ADDENDUM 1

TO: PROJECT MANUAL AND DRAWINGS

FOR: CENTRAL HOUSE AND GARDEN
606 East Central, Bentonville, AR

October 16, 2026

E201

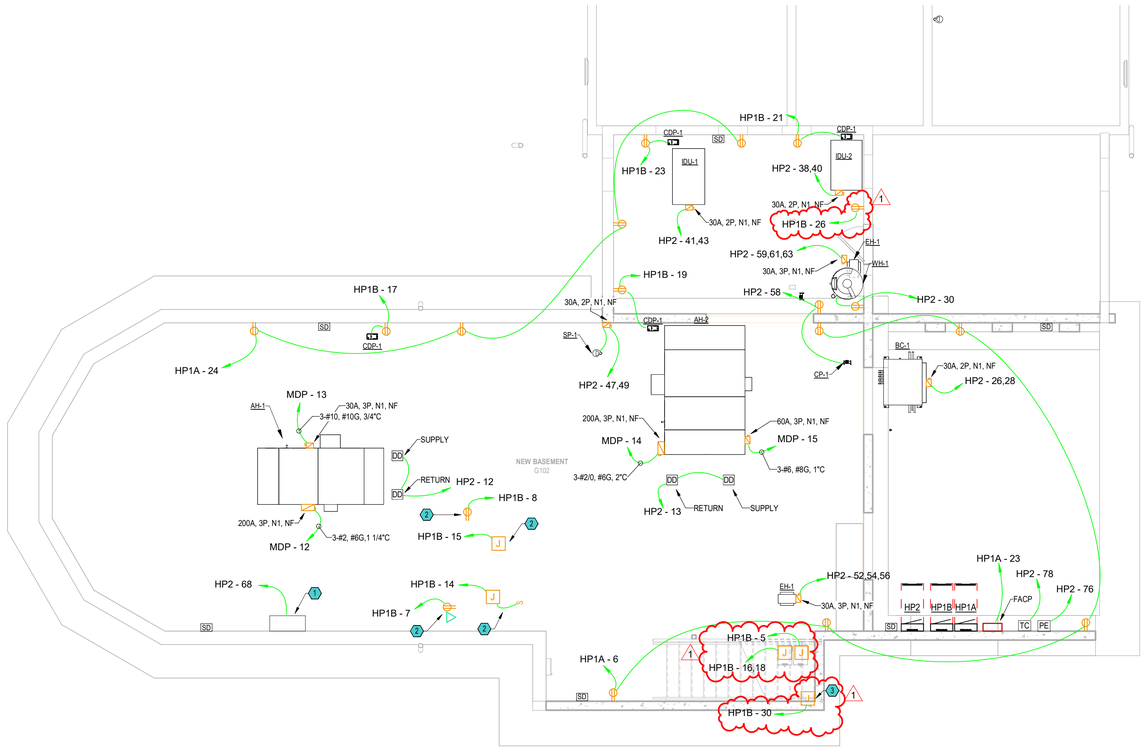
2. Refer to Revised Sheet E201 – SITE PLAN - ELECTRICAL – revision dated 10/16/26:

A. Added electrical connection for neon sign.
   B. Added electrical connection for future gate operation.
   C. Updated utility transformer location based off of civil drawings.

E305

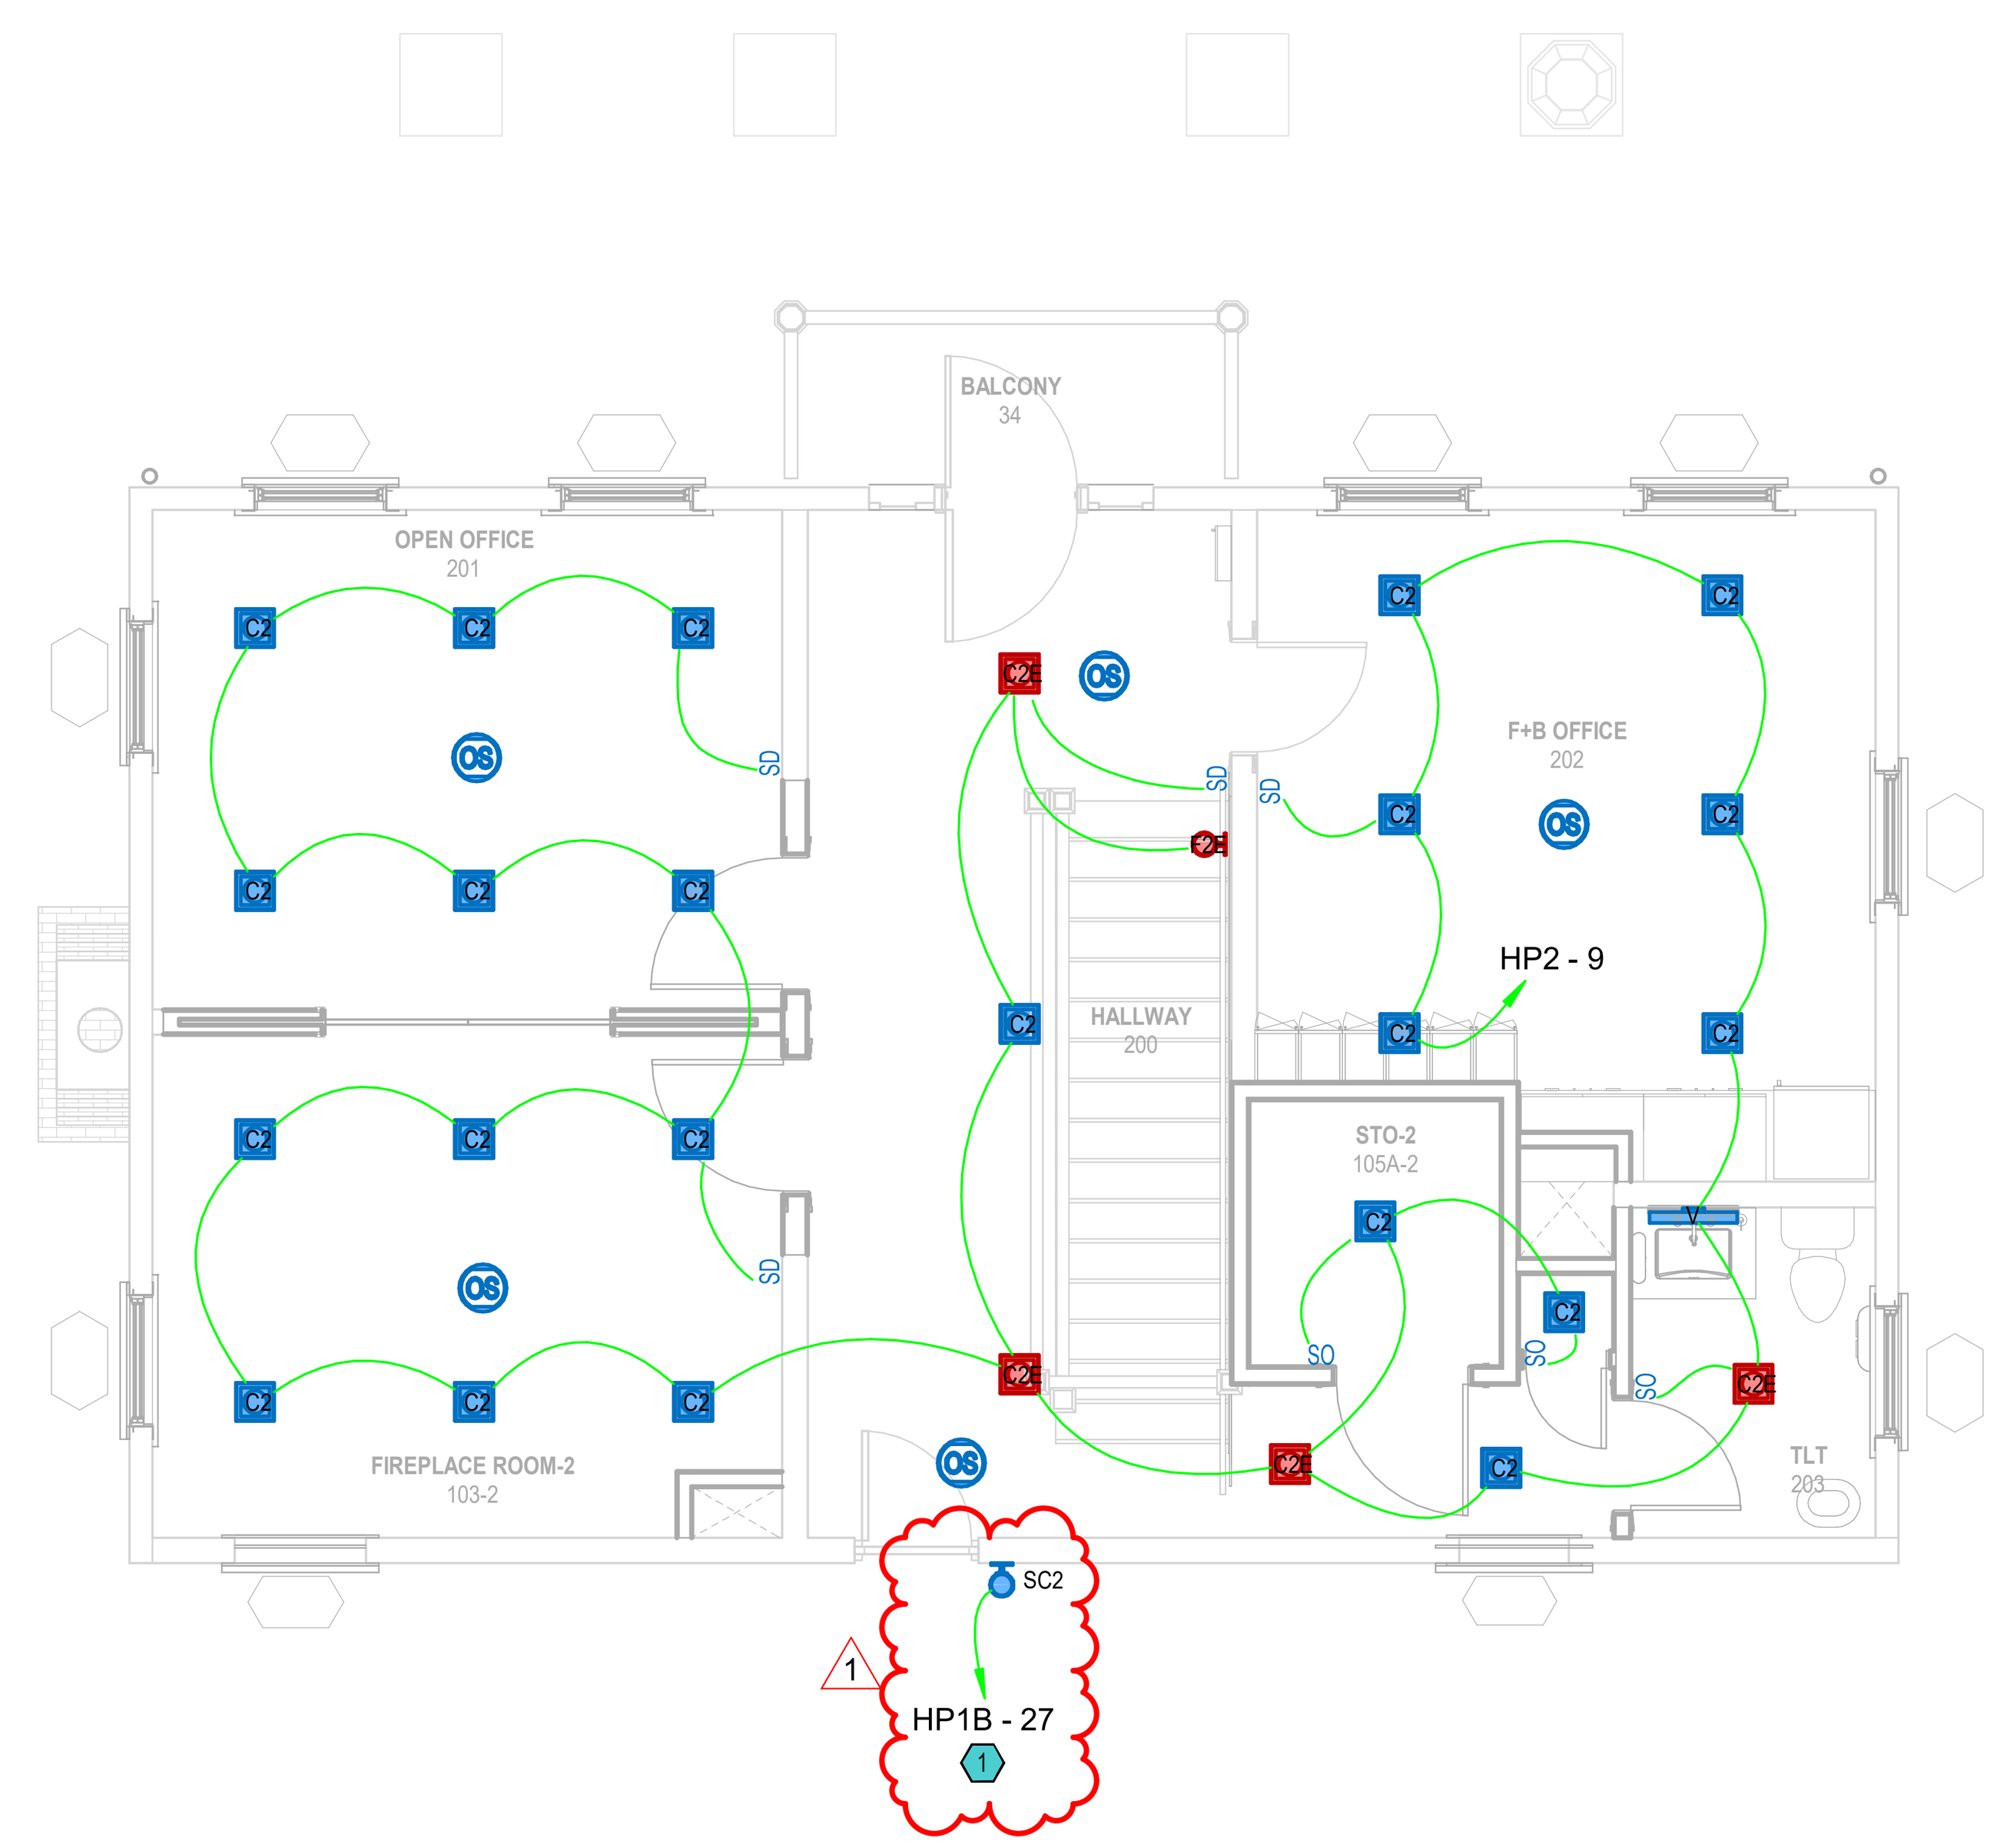
6. Refer to Revised Sheet E305 – FIRST FLOOR PLAN - SYSTEMS – revision dated 10/16/26:

A. Added wireless access point connections.
    B. Added speakers throughout the building.
    C. Added cameras throughout the building.

SECOND FLOOR PLAN - POWER AND SYSTEMS

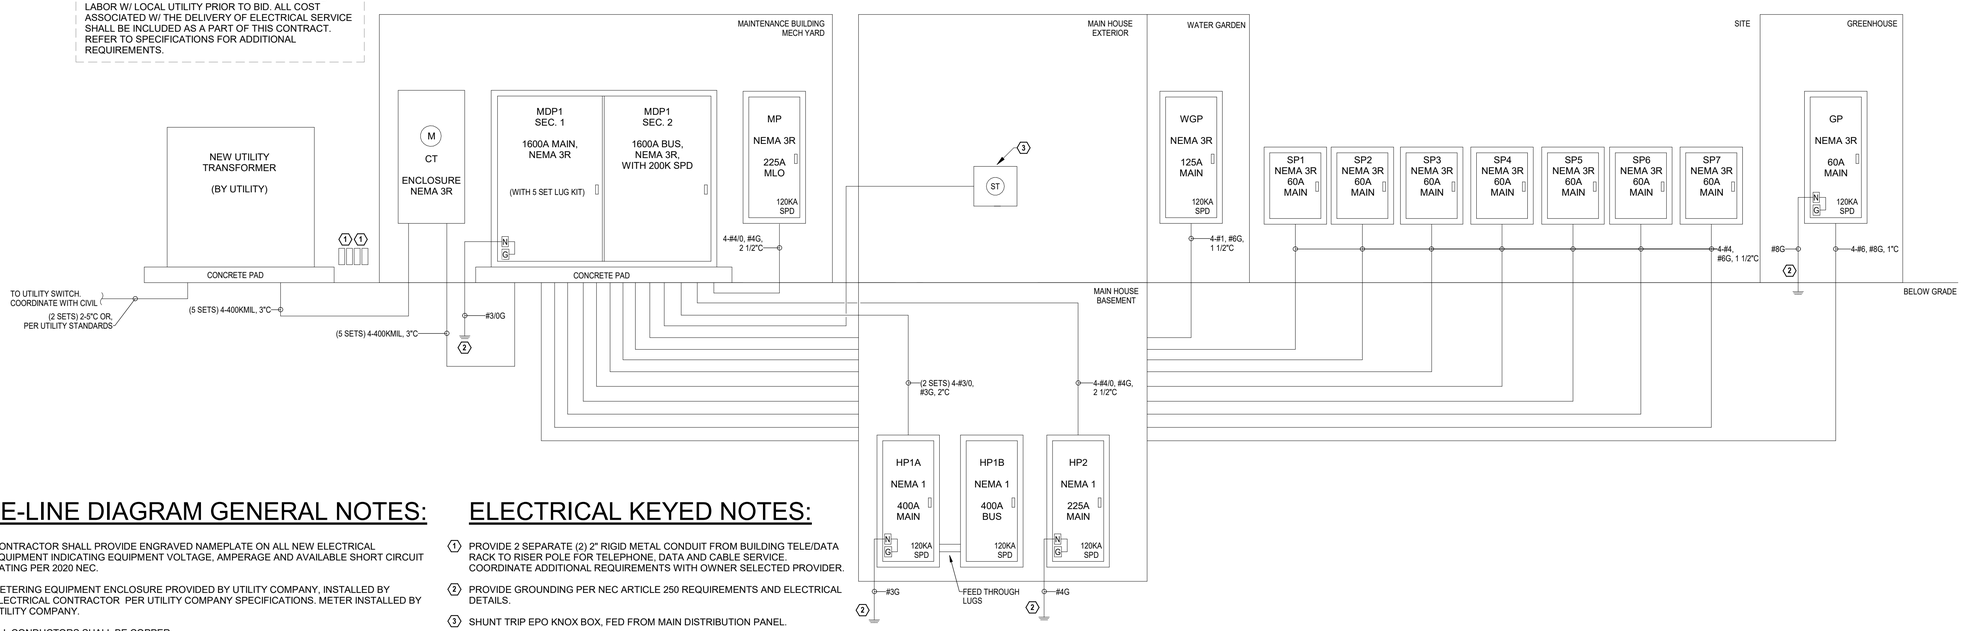
8. Refer to Revised Sheet E307 – SECOND FLOOR PLAN – POWER AND SYSTEMS – revision dated 10/16/26:

A. Added convenience outlet for outdoor HVAC units.
    B. Added more data drops.

FP201

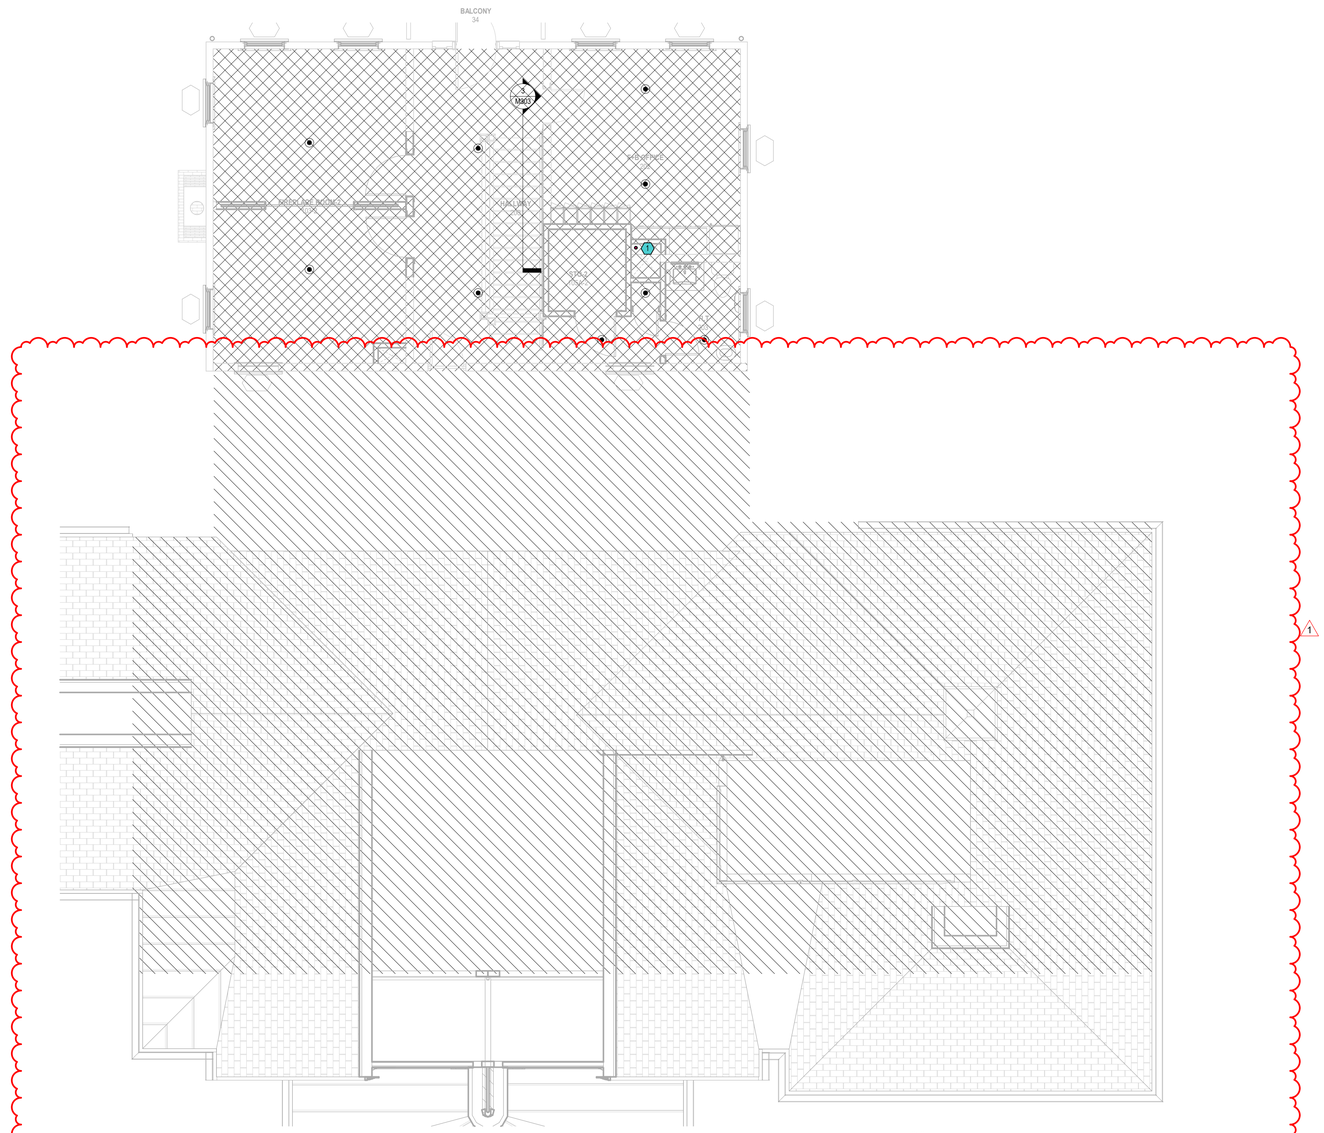
1. Refer to Revised Sheet FP201 – BASEMENT FLOOR PLAN – FIRE PROTECTION – revision dated 10/16/26:

1 BASEMENT FLOOR PLAN - MECHANICAL

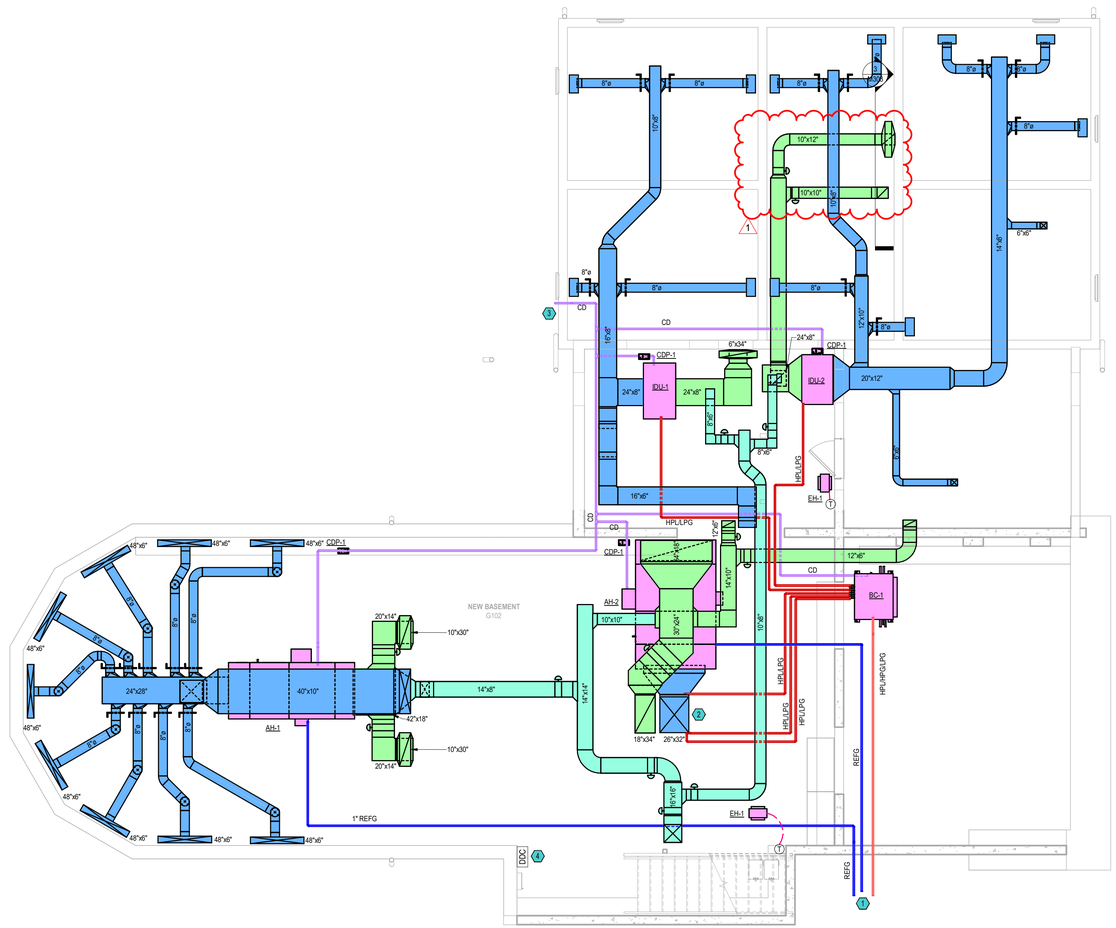
1. Refer to Revised Sheet M201 – BASEMENT FLOOR PLAN – MECHANICAL – revision dated 10/16/26:

A. Revised return ductwork for IDU-2.
   B. Add condensate drain line from BC-1.
   C. Added BAS controller along with keyed note 4.

M501

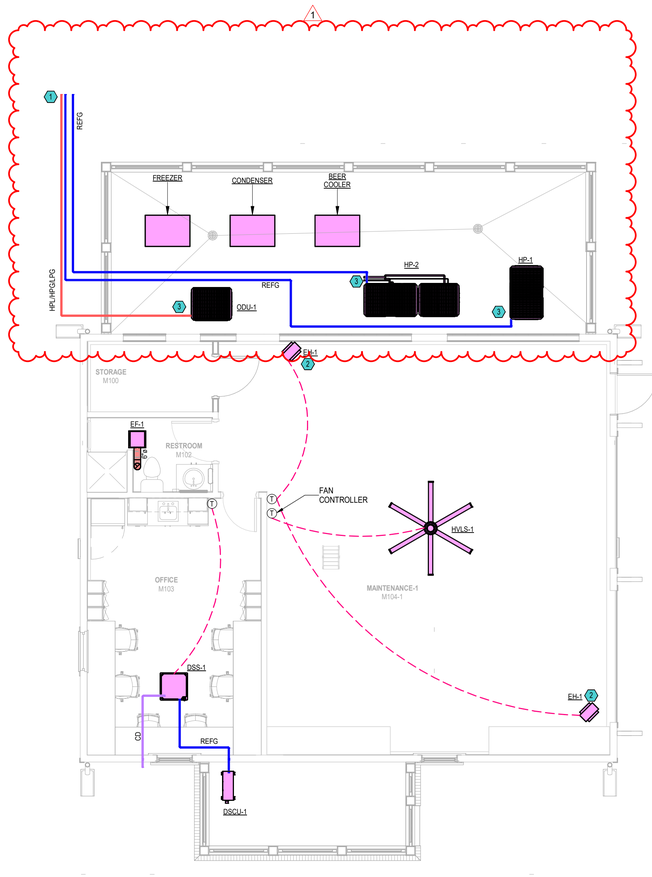
8. Refer to Revised Sheet M501 – CONTROLS – HVAC – revision dated 10/16/26:

A. Combined AH-1 and AH-2 controls into one, adjusted the sequence, and added a points diagram.
   B. Renumbered details.
